**MINERALS PROGRAM INSPECTION REPORT**  
**PHONE: (303) 866-3567**

<b>MINE NAME:</b> Dowe Flats Mine	<b>MINE/PROSPECTING ID#:</b> M-1993-041	<b>MINERAL:</b> Limestone and shale	<b>COUNTY:</b> Boulder
<b>INSPECTION TYPE:</b> Monitoring	<b>INSPECTOR(S):</b> Amy Eschberger	<b>INSP. DATE:</b> November 5, 2019	<b>INSP. TIME:</b> 14:30
<b>OPERATOR:</b> CEMEX, Inc.	<b>OPERATOR REPRESENTATIVE:</b> Cita Cisse, Scott Harcus, Robin Bay	<b>TYPE OF OPERATION:</b> 112c - Construction Regular Operation

### **Technical Revision No. 2 (Updated Mining and Reclamation Plans; Approved October 22, 2009):**

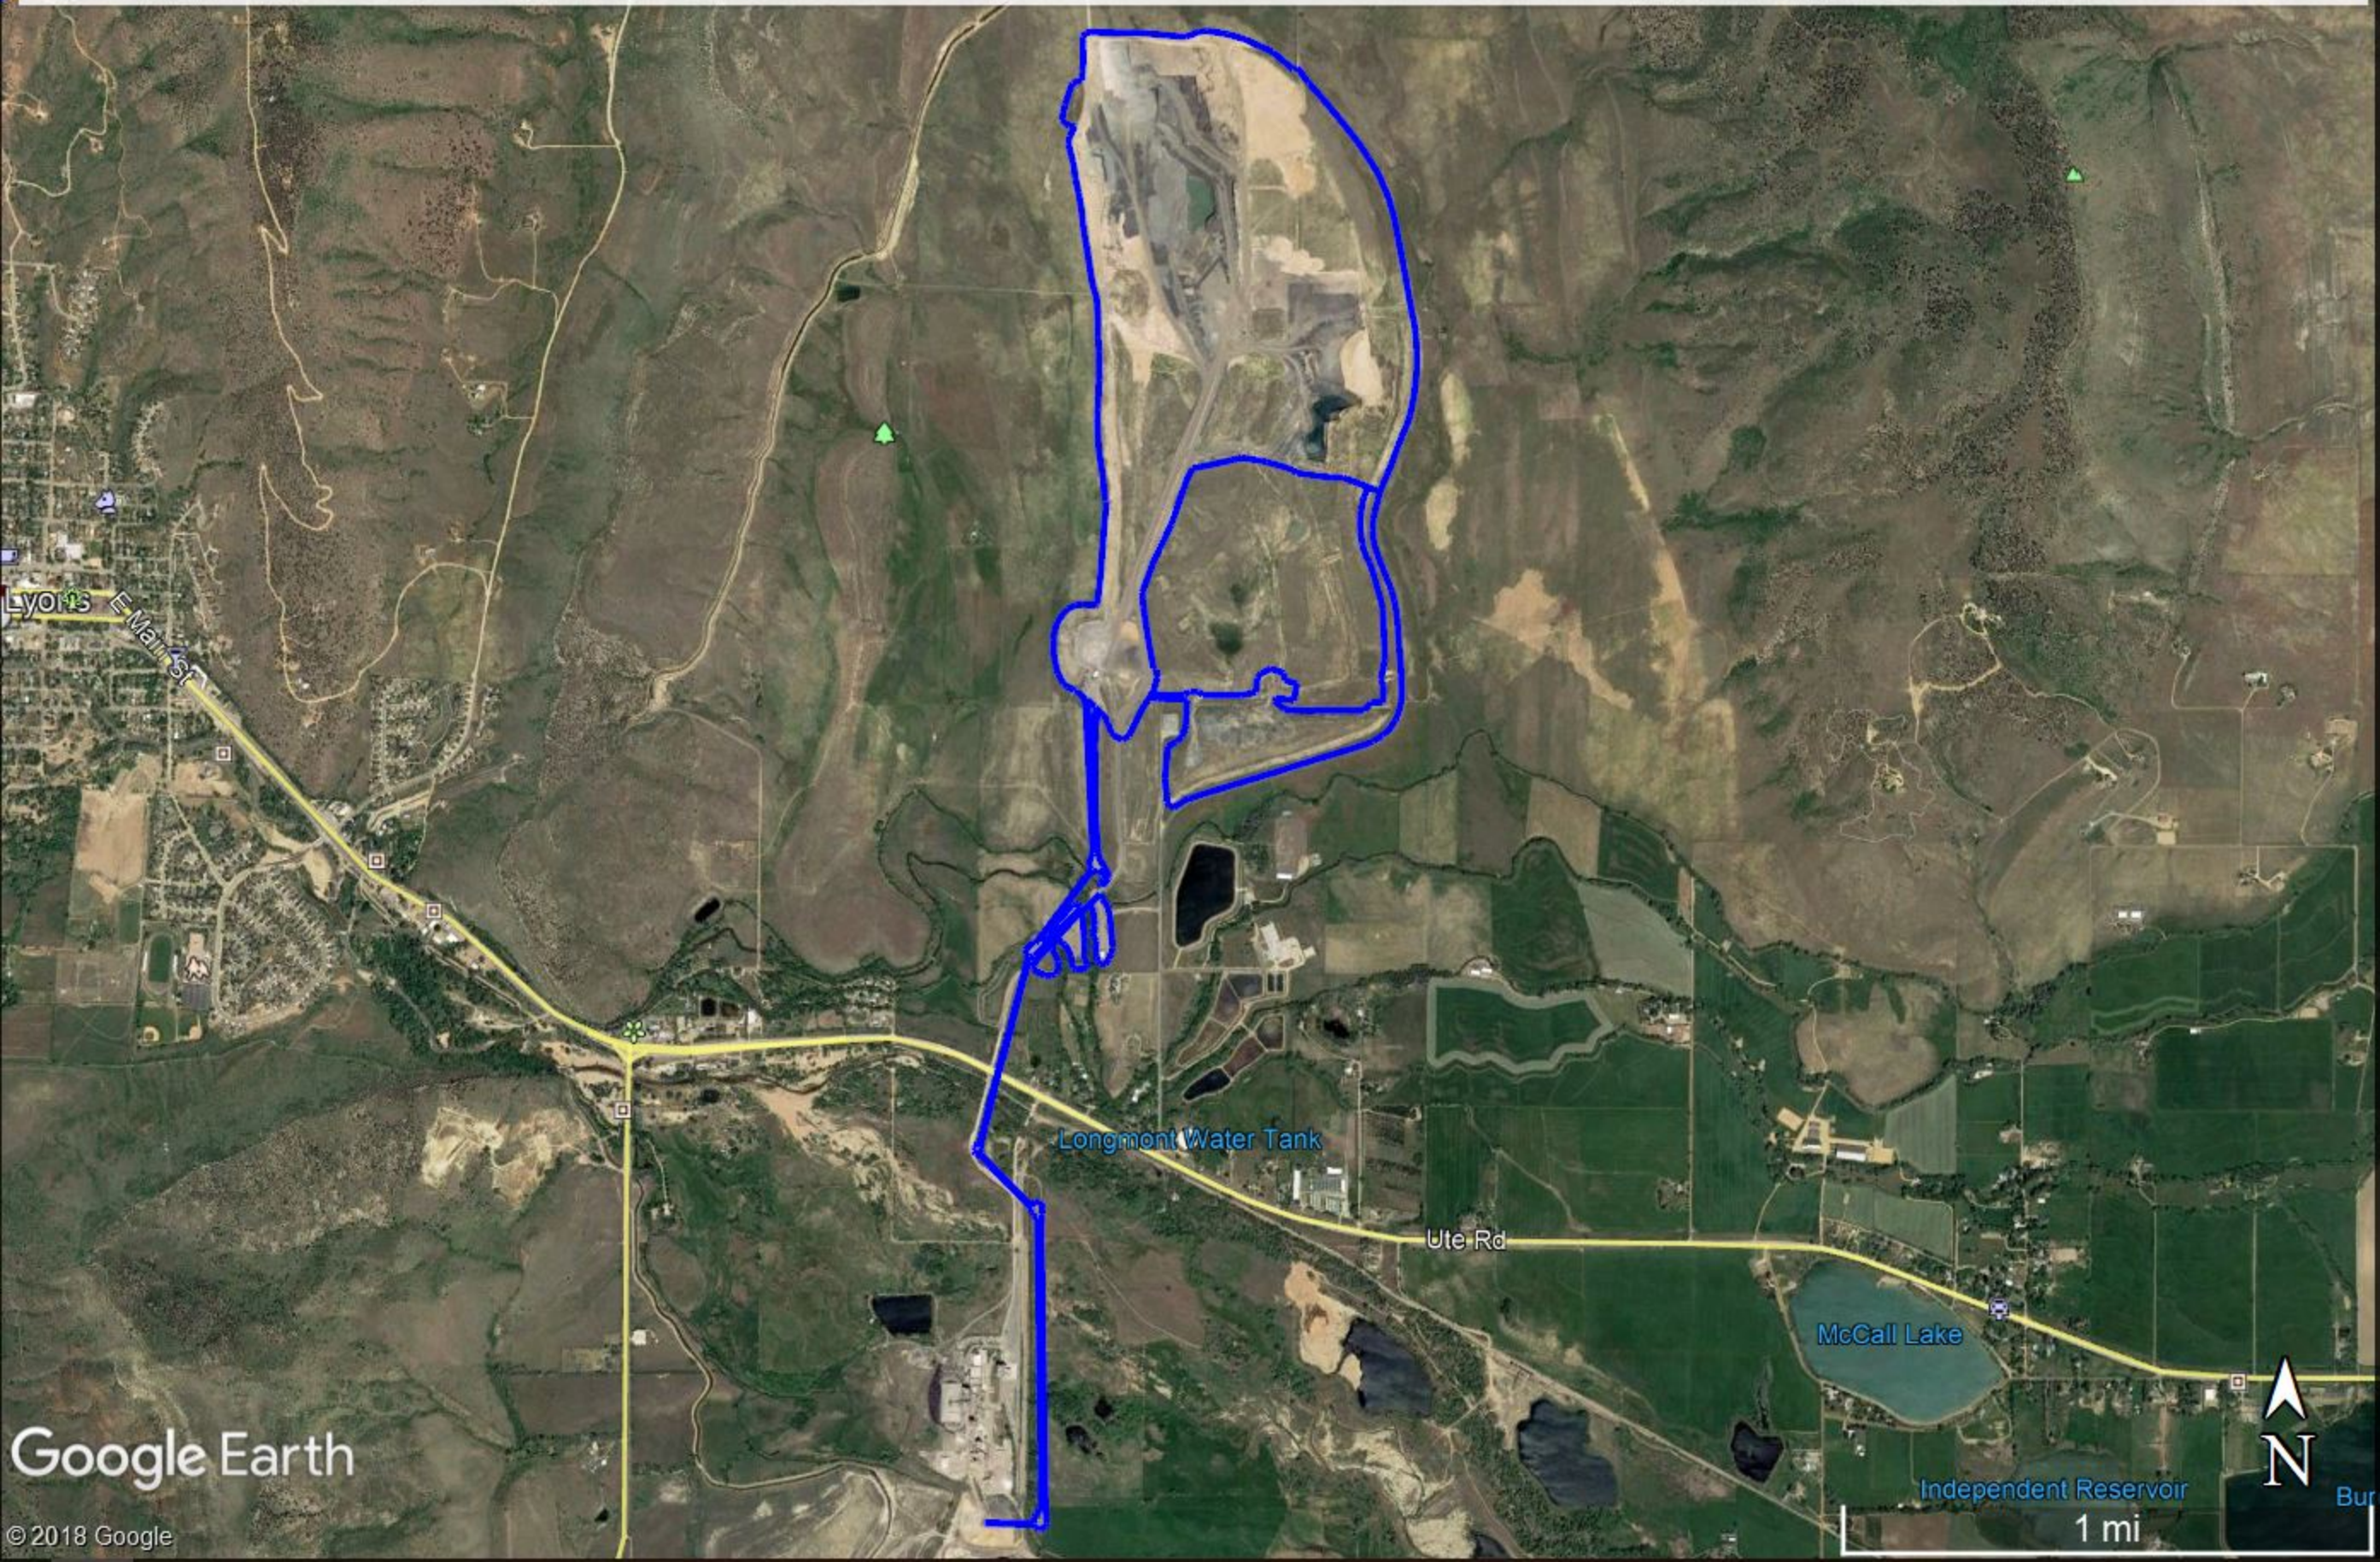
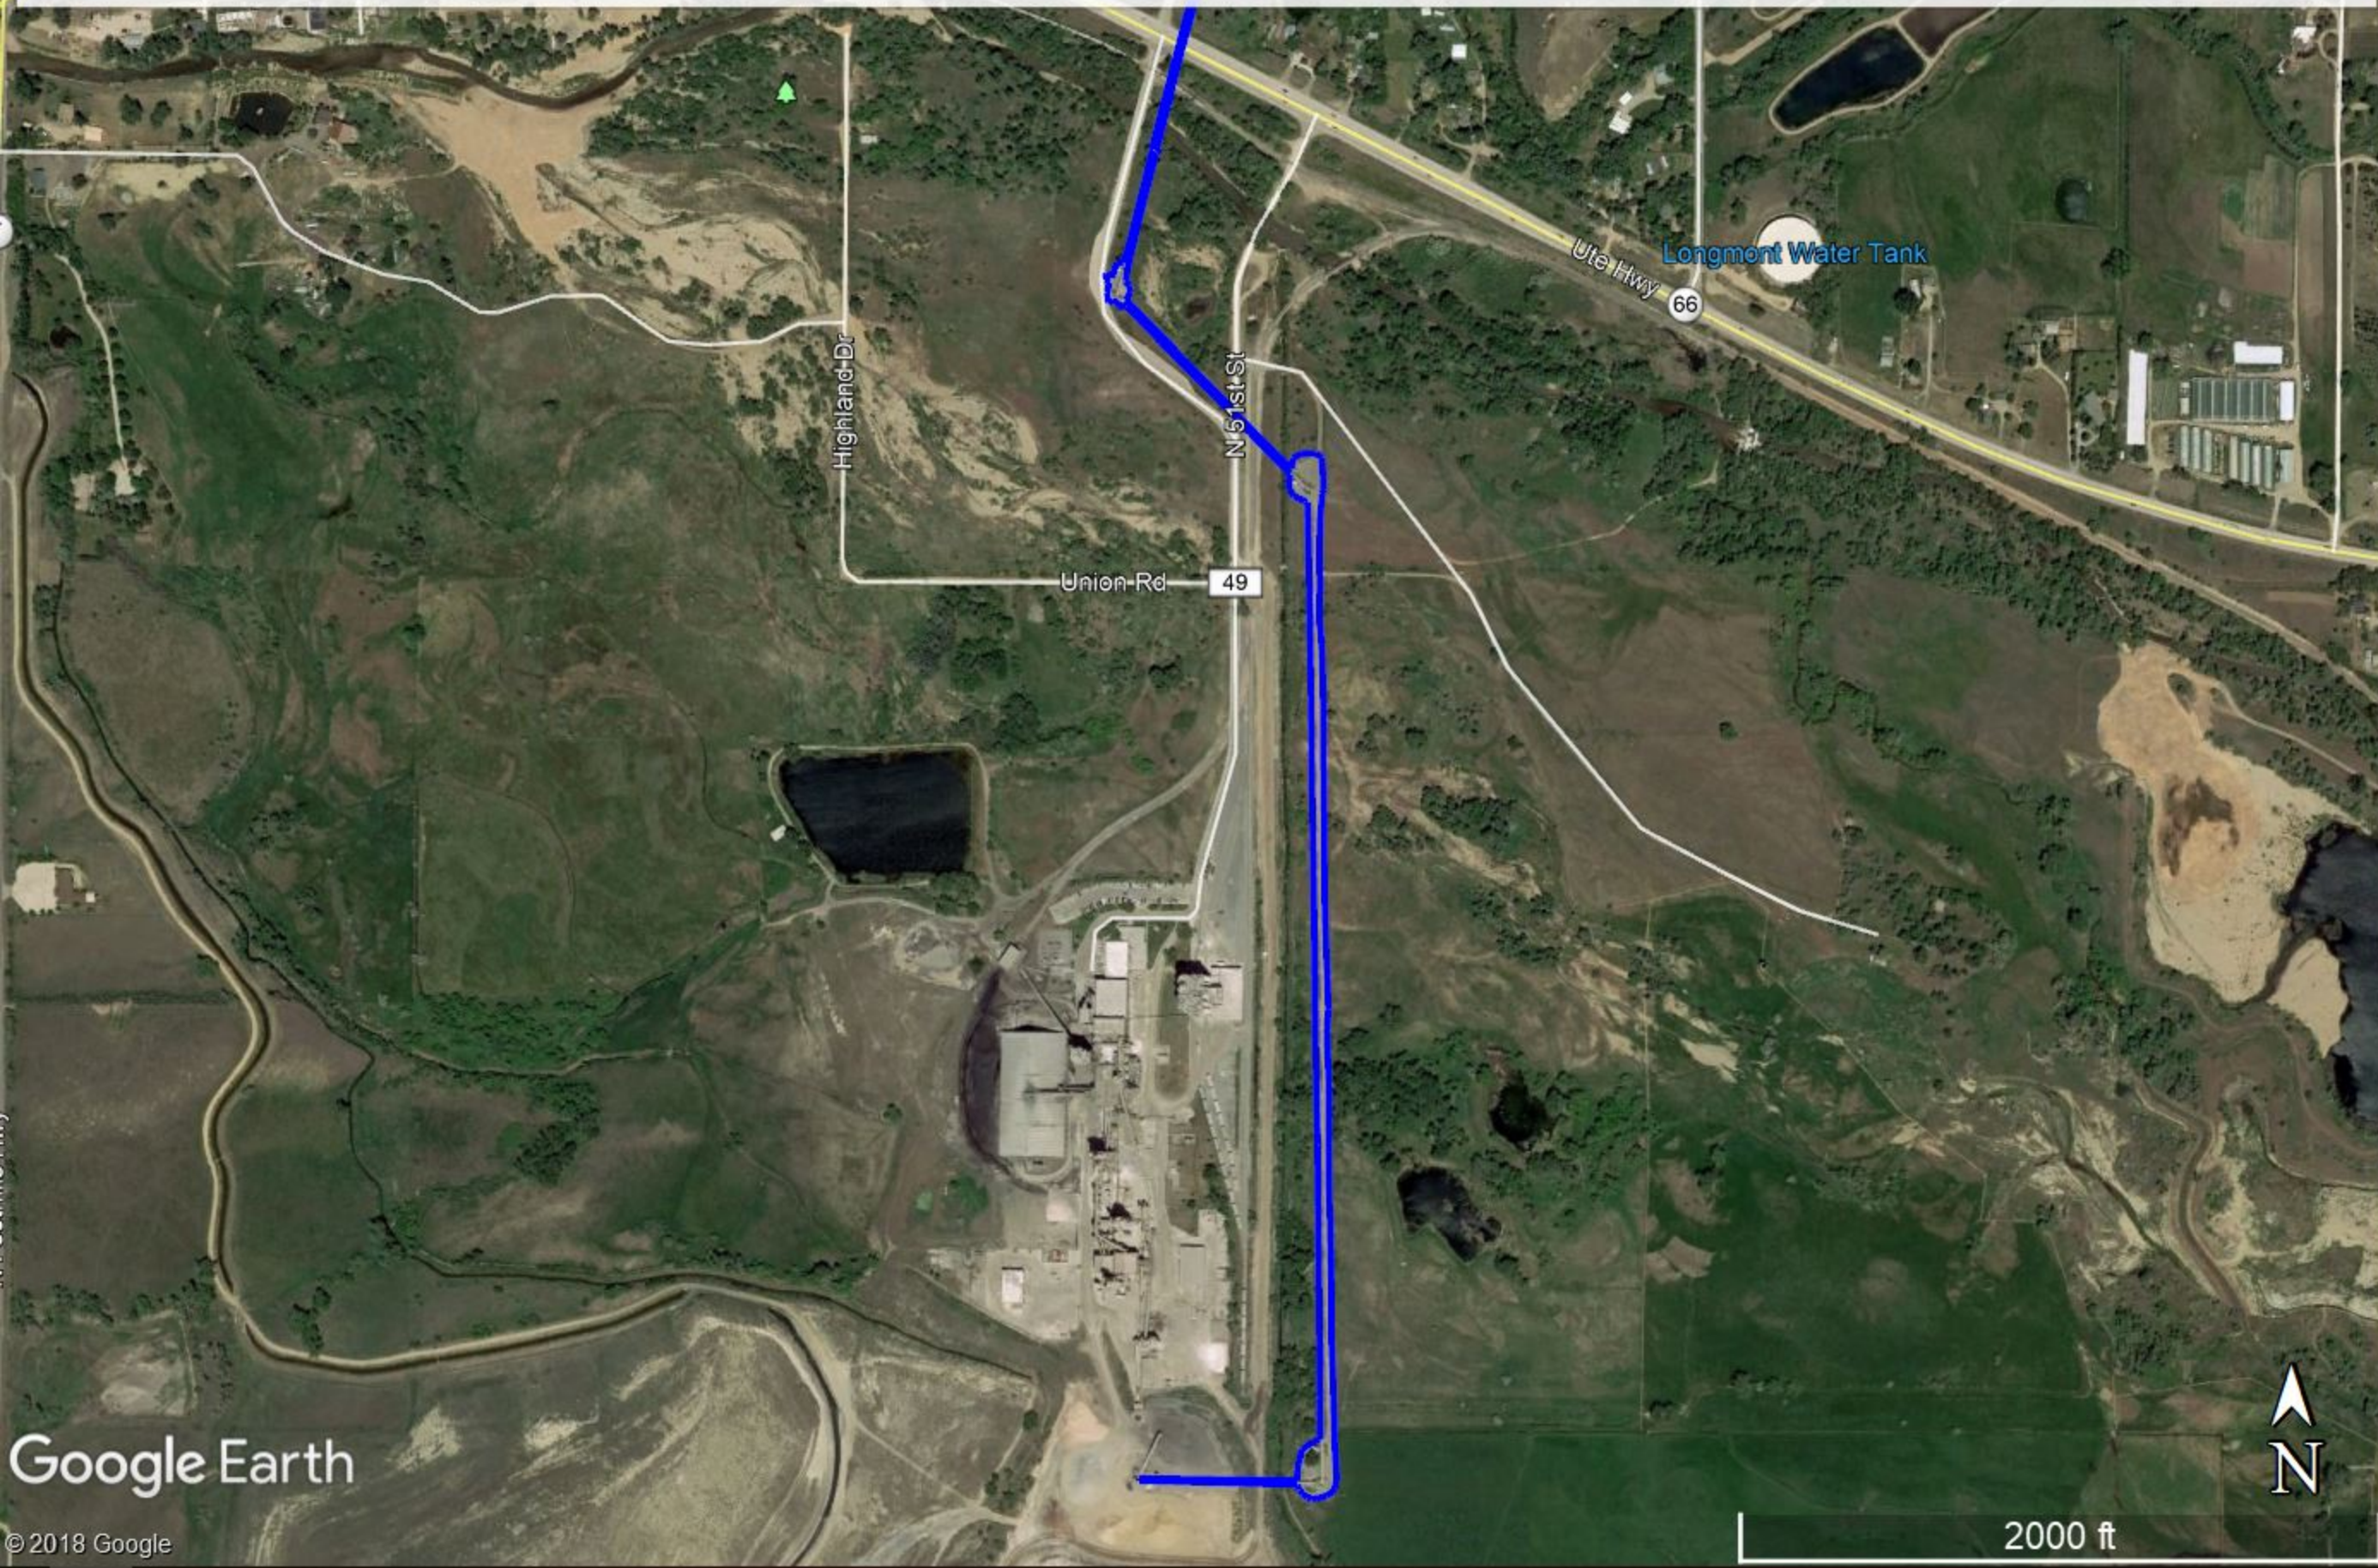
The Division estimates (based on the most recent aerial image available for the site in Google Earth, dated May 31, 2018), total unreclaimed disturbance to total 385.15 acres (see enclosed Google Earth images 1-4 of site

showing total unreclaimed disturbance). This includes 329 acres of disturbance associated with the active pit and crusher areas, 42.6 acres of disturbance associated with overburden and topsoil stockpiles (located outside of the active pit area), 6.7 acres of disturbance associated with the maintenance shop, fuel station, and equipment storage areas (located near the mine entrance), and 6.85 acres of disturbance associated with the conveyor system.

The Division's estimated disturbance at the site (385.15 acres) far exceeds the maximum amount of disturbance (105 acres) that is authorized for the operation per TR-2. Therefore, a problem is cited in this report (see page 1), requiring the operator to submit a Technical Revision (form enclosed) to increase the maximum amount of disturbance to reflect, at a minimum, existing site conditions. This revision shall include a description of current disturbances and the reclamation that remains for these areas.

- e) Provide an updated bond estimate that includes costs for reclaiming, at a minimum, the existing disturbance in accordance with the approved reclamation plan per Rule 6.4.12. This estimate shall include costs for demolishing/removing all permanent structures that will not remain for reclamation, including the conveyor system and associated infrastructure.
